MC Servo Amp Rev A
 MC Servo Amp Rev A Sch

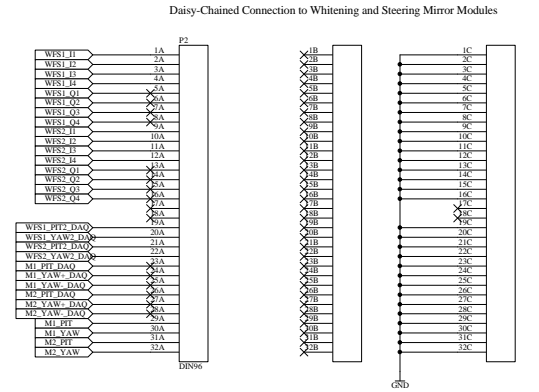
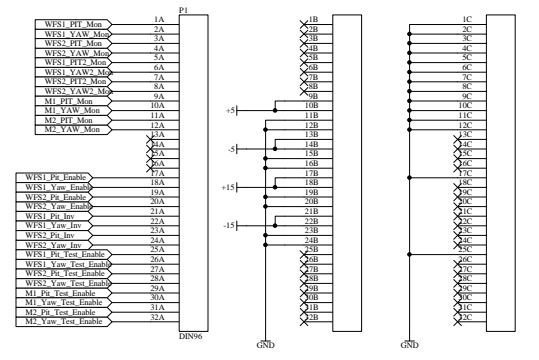
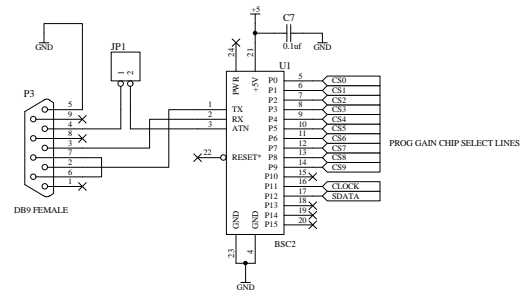
Revision	Description of Change	Date
01	1. R70 and R75 are removed from original design to correct Pitch calculation. 2. R97 rewired on board from original design to correct Yaw calculation. R98 and R68 are removed. 3. R56 and R61 are removed from original design to correct Pitch calculation. 4. R95 rewired on board from original design to correct Yaw calculation. R96 and R54 are removed. 5. Radd1, Radd2, Radd3, Radd4 added to original design as pull downs for U11 switch outputs.	6/99
A	1. All changes described in Rev 01 implemented 2. Jumpers JP1-4 and corresponding resistors added to allow field changes to output matrix calculation.	6/99
